**STATE OF TENNESSEE
DEPARTMENT OF TRANSPORTATION**

INSTRUCTIONAL BULLETIN NO. 15-03

Regarding Revised Standard Drawings

Effective May 15, 2015 letting (March 4, 2015 Turn-in), the following Standard Drawings are revised and Section V of the Design Guidelines is revised for this update

STRAIGHT
 CONCRETE ENDWALL

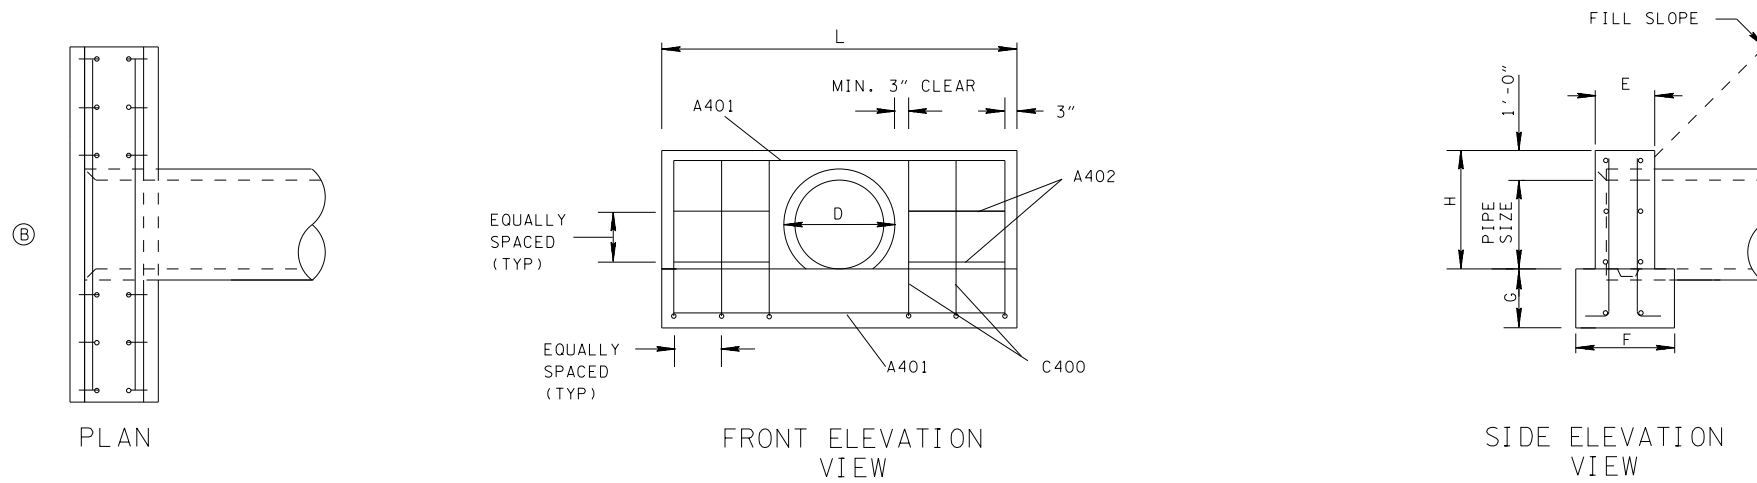
- REV. 9-28-83: REDREW AND ADDED TABLE FOR STRAIGHT ENDWALL WHEN PIPE IS SKEWED.
- REV. 2-19-88: ADDED SAFETY ADJUSTMENTS "U" TYPE ENDWALL.
- REV. 1-19-94: REDREW AND REORGANIZED DRAWING. ELIMINATED TYPE "U" ENDWALL FOR 3:1 SLOPE.
- REV. 1-19-97: ADDED UNITS TO HEADING FOR TABLE FOR SKEWED PIPE.
- REV. 6-1-09: ADDED GENERAL NOTE (D).
- REV. 7-19-10: REMOVED GENERAL NOTE (D).
- REV. 1-15-13: ADDED REINFORCEMENT AND CHANGED NOTES. ADDED BILL OF STEEL. REMOVED "U" AND "L" TYPE ENDWALL.
- REV. 12-1-14: REVISED BAR DESIGNATION MINOR EDITING.

SIGNING AND PAVEMENT MARKINGS FOR BICYCLE LANE OR ROUTES

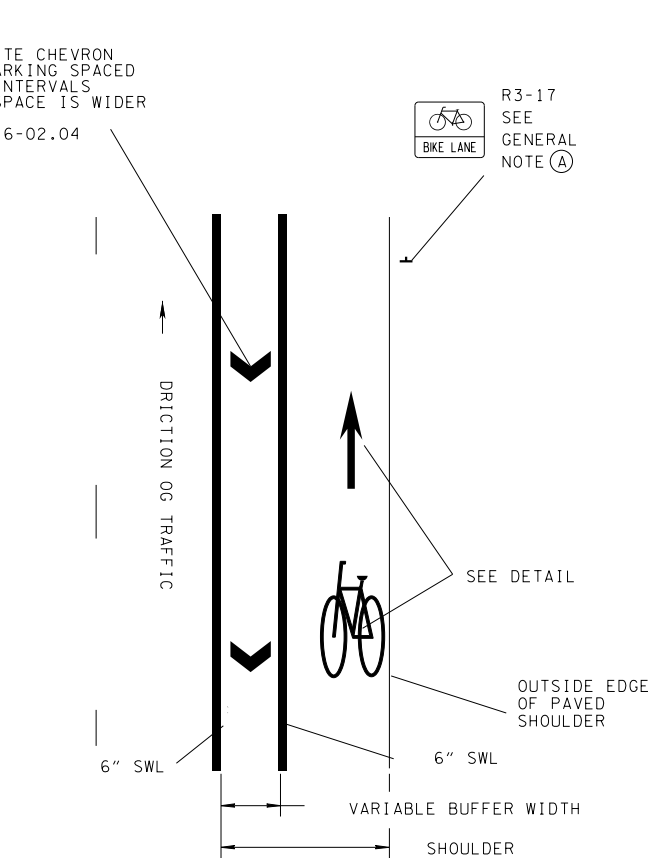
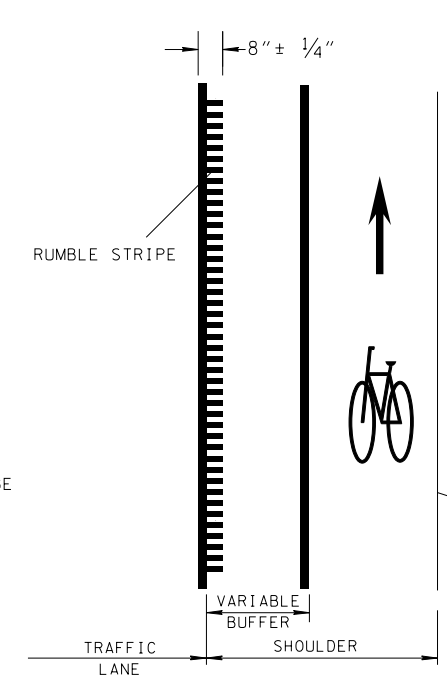
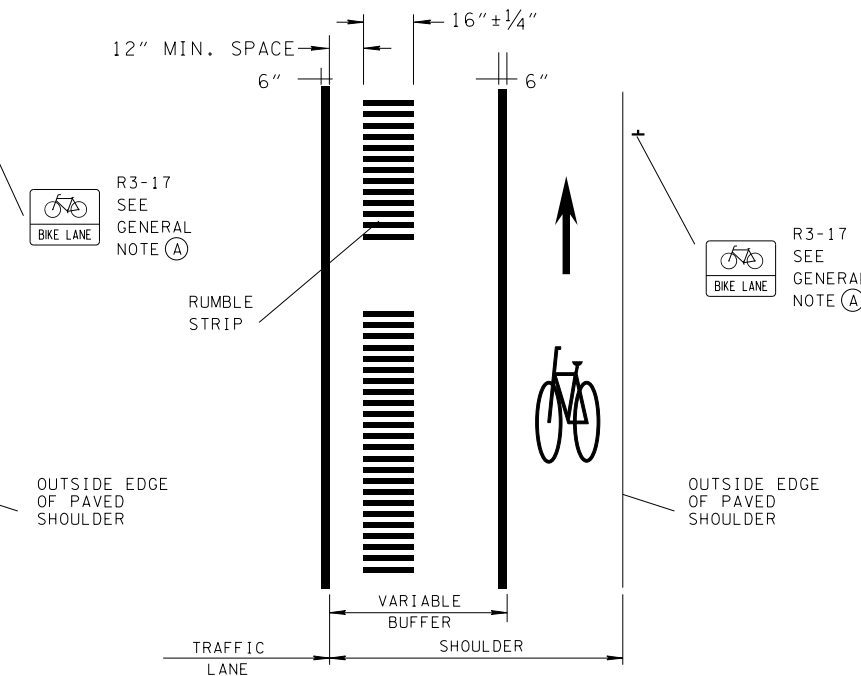
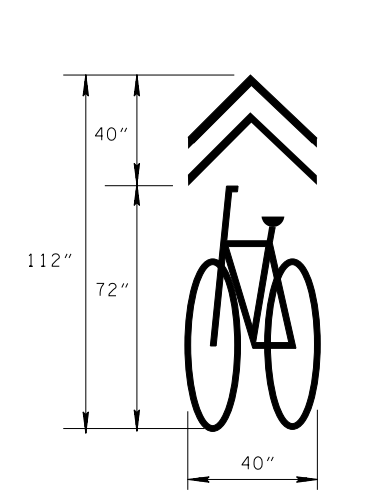
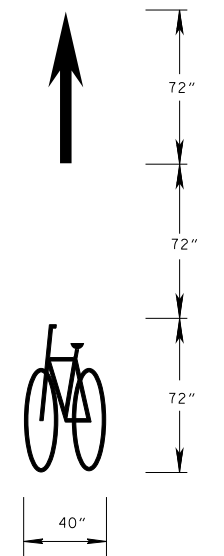
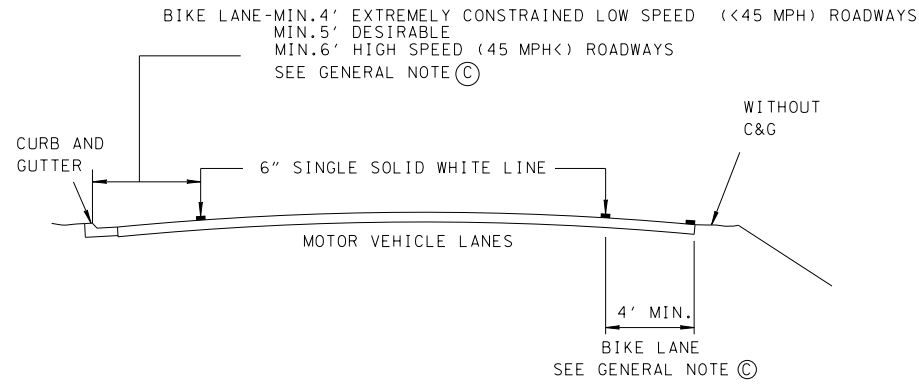
- REV. 12-1-09: REMOVED RUMBLE STRIPE DETAILS TO T-M-15 AND 15A.
- REV. 11-1-11: REVISED GENERAL NOTE (B), ADDED GENERAL NOTE E AND (F), UPDATED PLAN VIEW, AND ADDED BIKE SYMBOL/ARROW SHARED LANE MARKING DETAIL.
- REV. 6-15-12: ADDED NOTE (C).
- REV. 10-24-13: ADDED NOTE (H).
- REV. 12-1-14: ADDED BUFFERED LANE DETAILS.

SIGNING AND PAVEMENT MARKINGS FOR BICYCLE LANES ON URBAN ROADWAYS

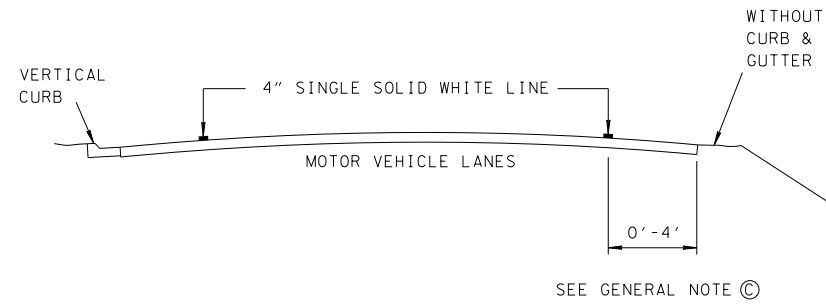
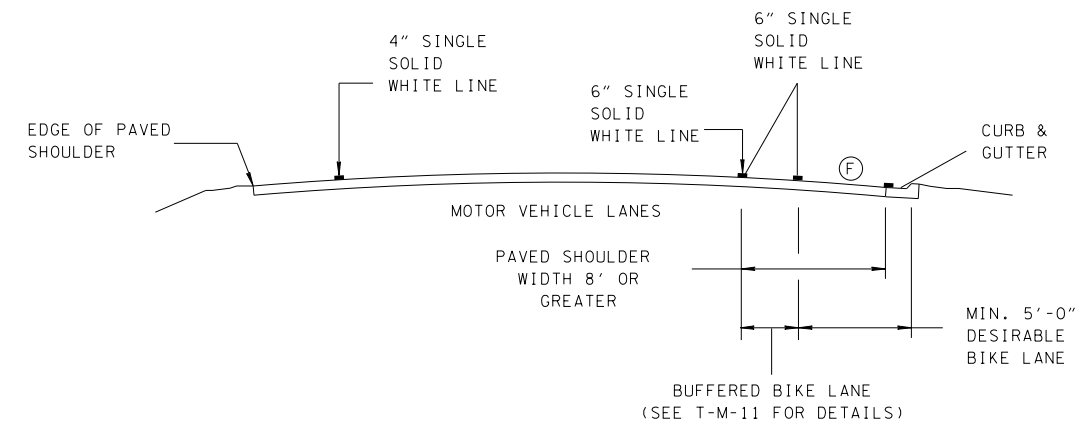
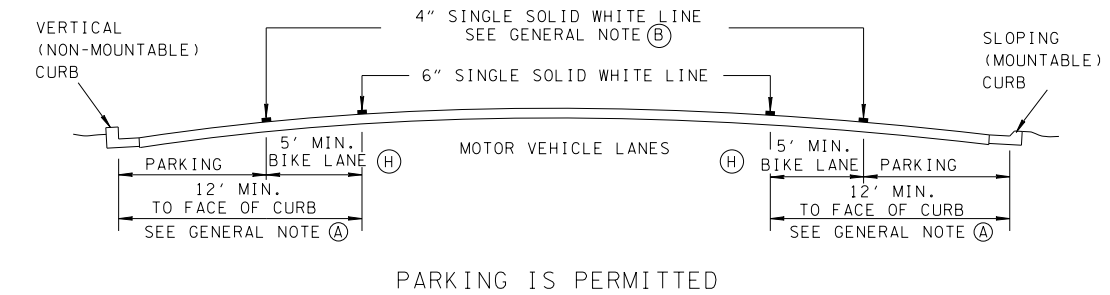
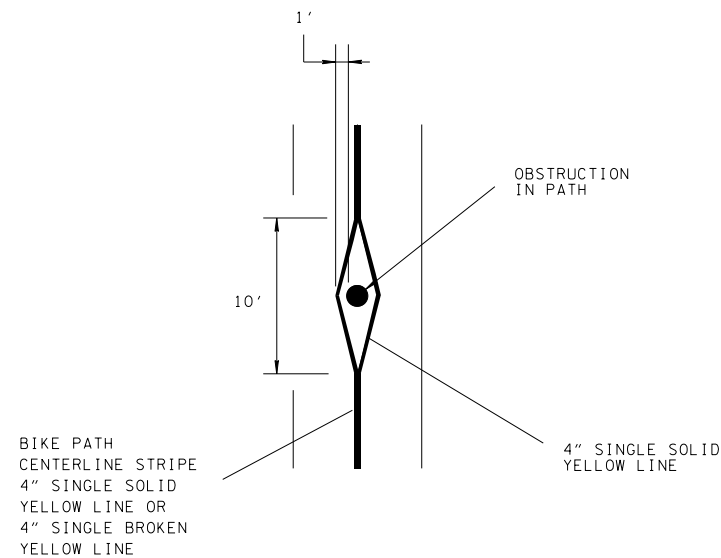
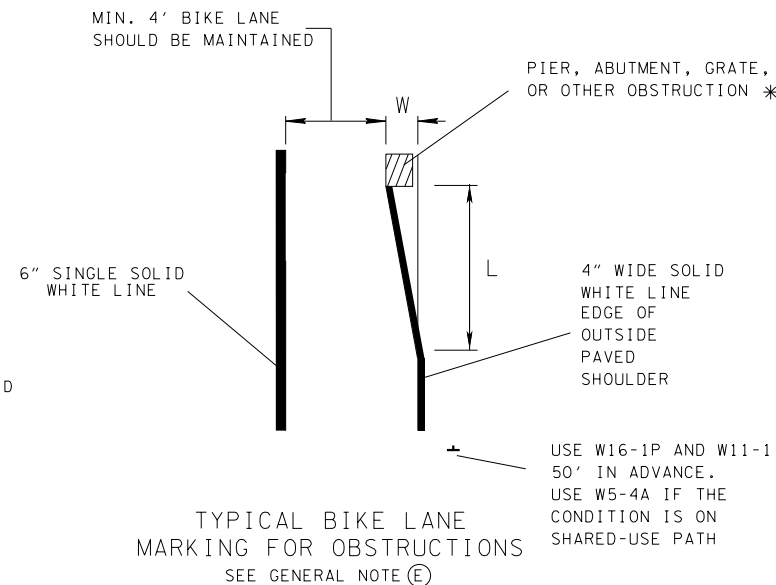
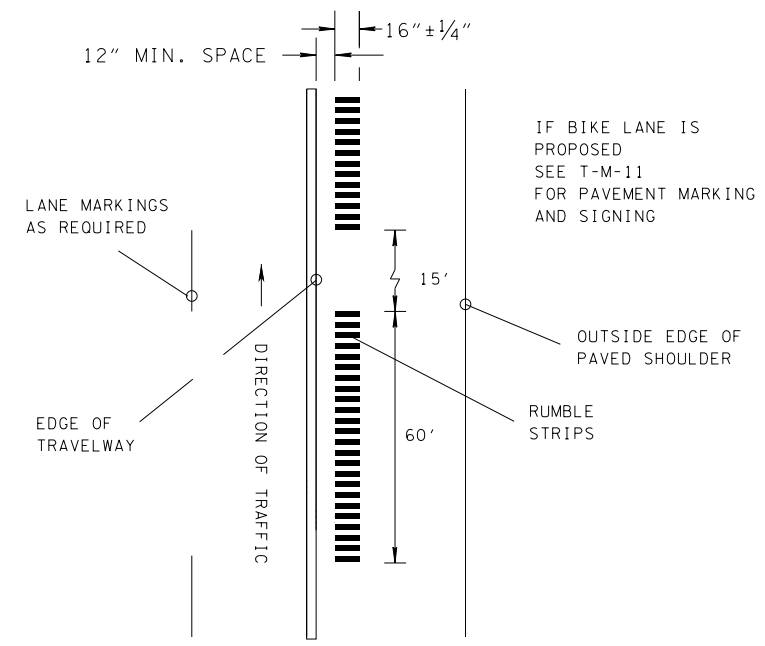
- REV. 12-1-09: ADDED SIGN NO. W5-4g AND CHANGED GENERAL NOTE (D) REARRANGED.
- REV. 11-1-11: ADDED BARRIER POST STRIPING DETAIL AND REVISED GENERAL NOTE (E)
- REV. 10-10-13: ADDED NOTE (G) AND (H)
- REV. 1-30-15: UPDATED BIKE LANE WIDTH AND GENERAL DRAFTING. REVISED NOTES.

ASPHALT SHOULDER RUMBLE STRIPE INSTALLATION DETAILS FOR NON-ACCESS CONTROLLED ROUTES

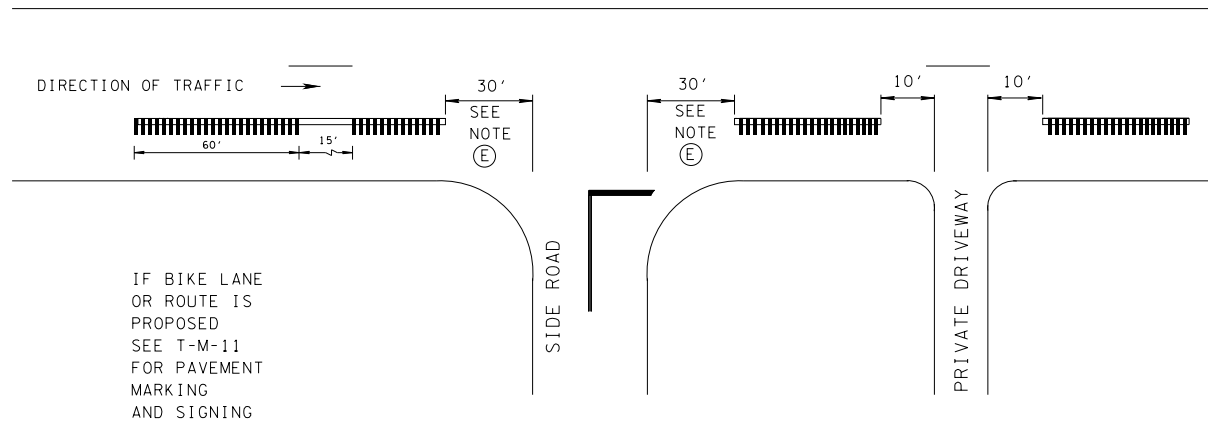
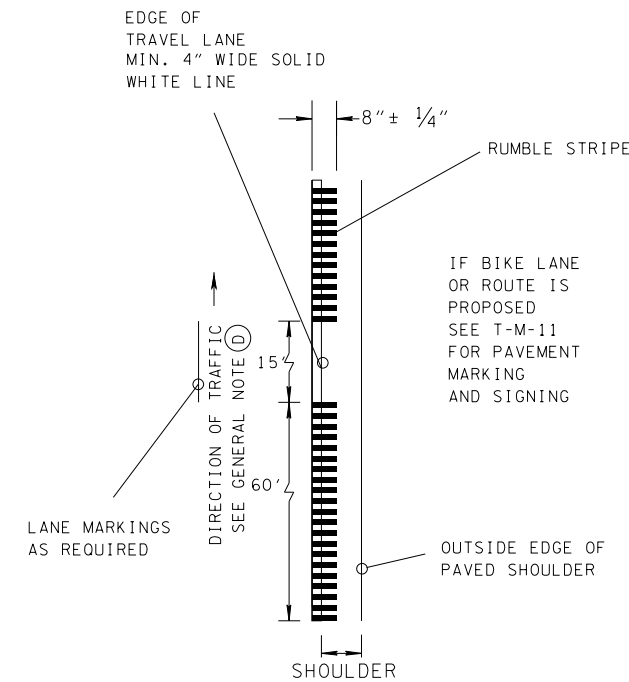
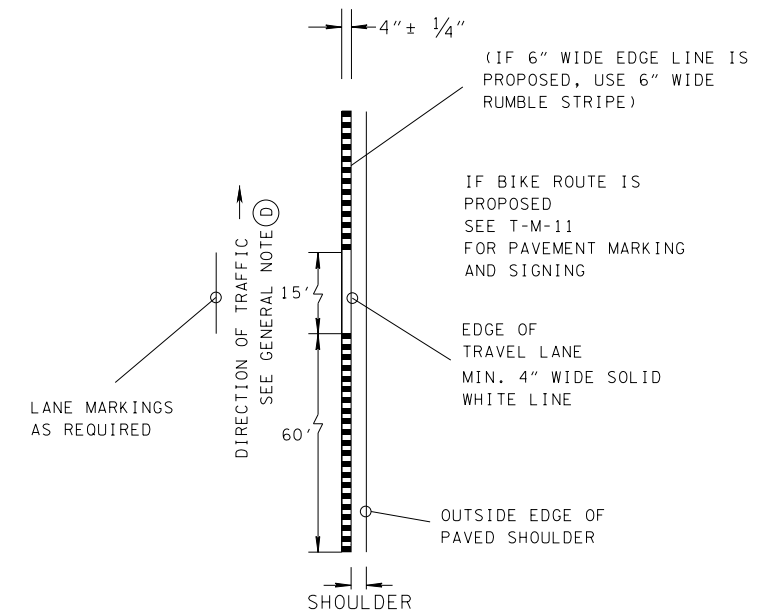
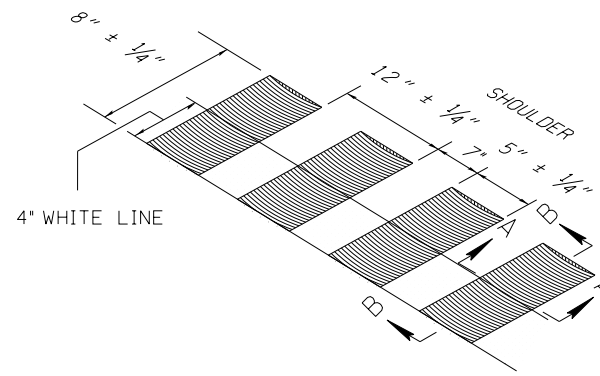
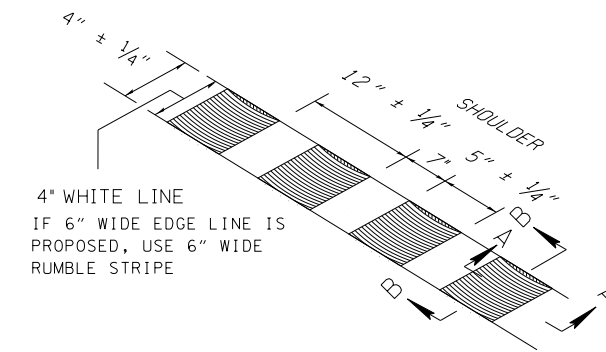
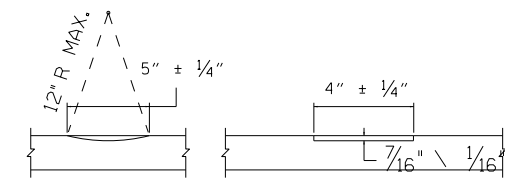
REV. 1-30-15: REVISED RUMBLE STRIPE SPACING.

REV. 12-1-14: REVISED RUMBLE STRIPE SPACING ADDED REFERENCE TO T-M-11.
